Note To: J. Wermiel  
From: E. Throm   
Subject: SSIB POST-LOCA CONTAINMENT REPORT

F. Akstulewicz asked me to review the subject report (attached) and provide feedback directly to you.

Figure 28: NPSH Margin Sample Calculation, Case 1 ABA M

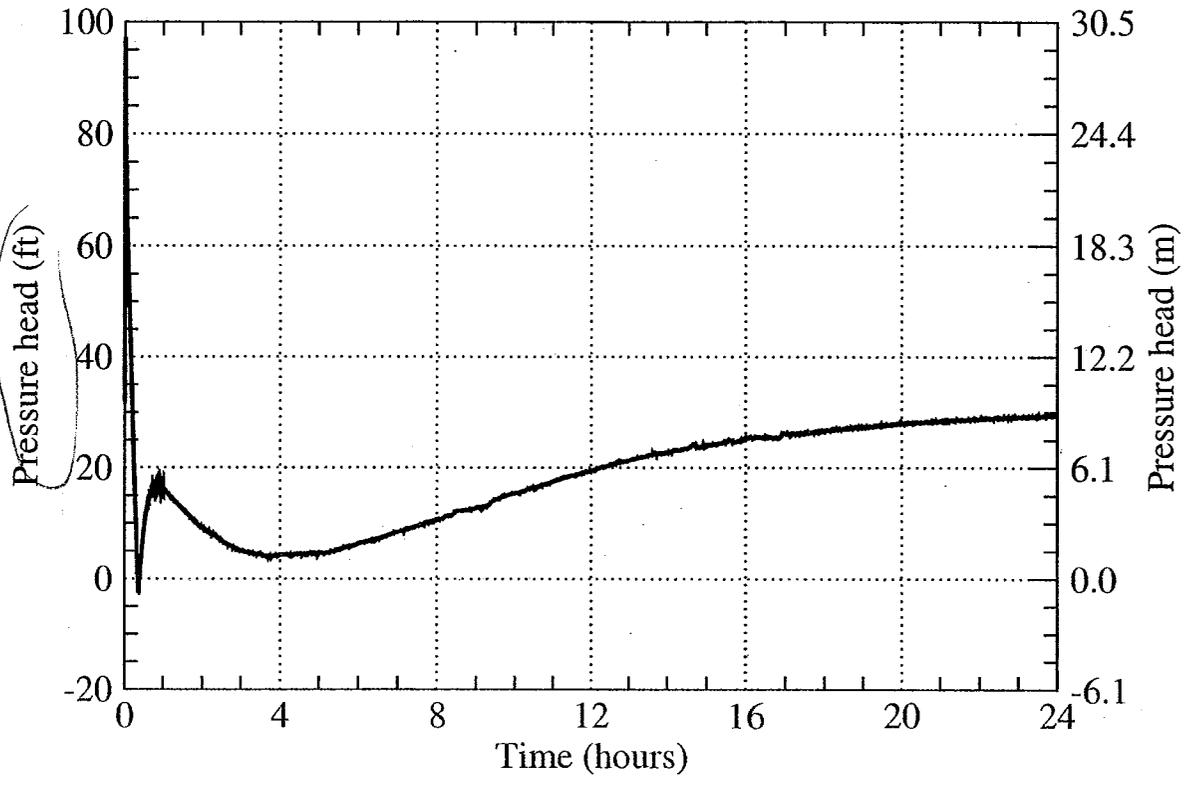
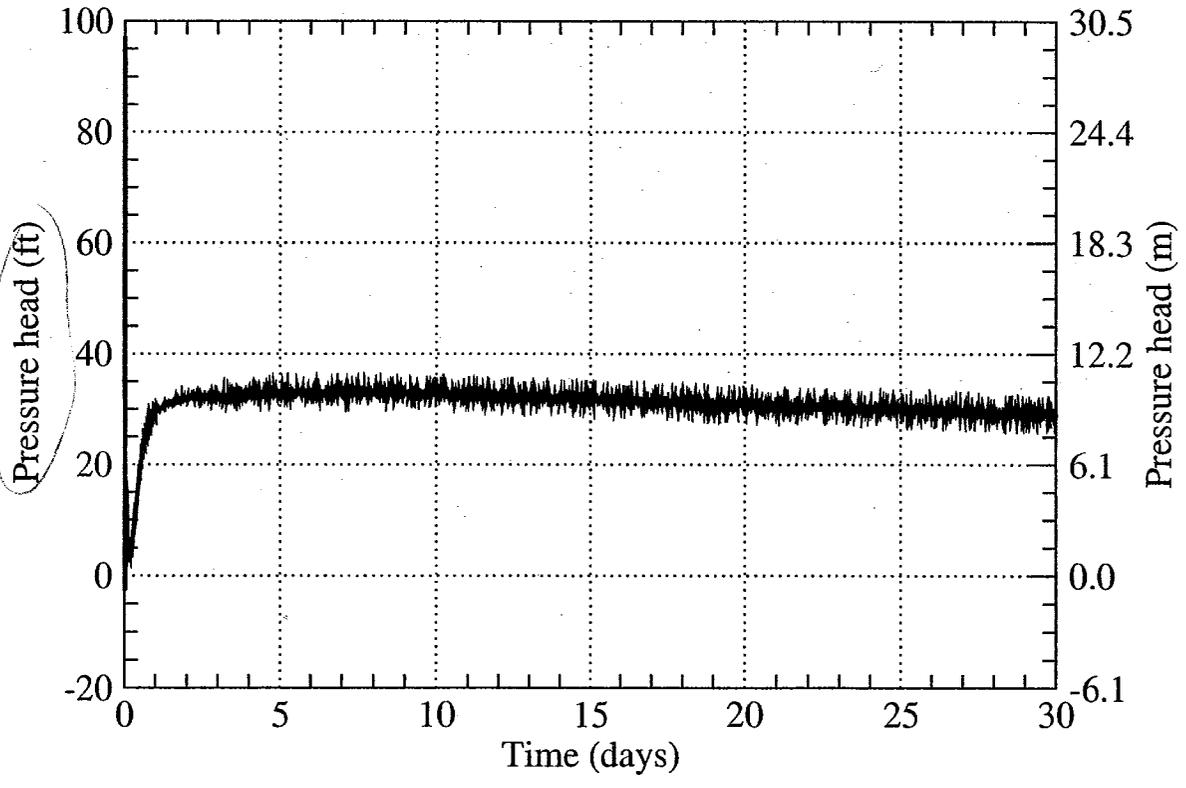
isn't this the most critical time?  
How accurate is water level?

explain chem eff  
longer to  
not work  
raise of  
Sump

the  
why are  
they  
doing  
calculation?  
not
